April 15, 2020  
GO2-20-052

Subject: **COLUMBIA GENERATING STATION, DOCKET NO. 50-397  
EXIGENT LICENSE AMENDMENT REQUEST FOR ONE-TIME CHANGE  
TO COMPLETION TIMES FOR INOPERABLE ELECTRICAL  
DISTRIBUTION SYSTEMS**

Proposed Columbia Technical Specification Changes (Mark-Up)

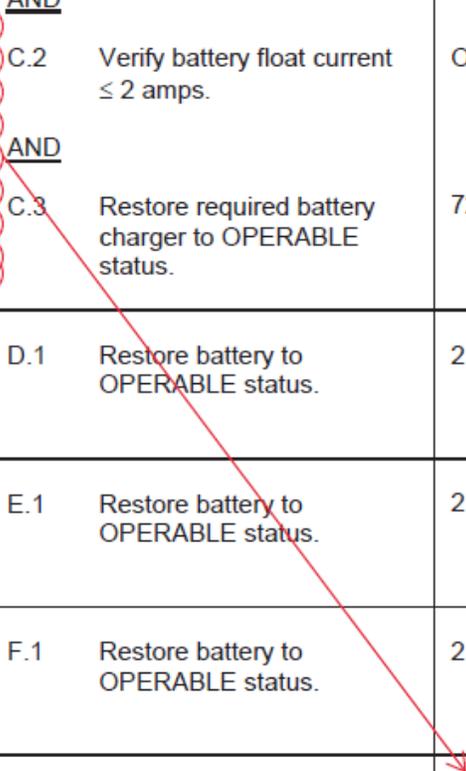
-----NOTE-----  
 Until June 30, 2021, a Completion Time of 16 hours is applicable for replacement of WMA-42-8F1E or its failed starter coil.  
 -----
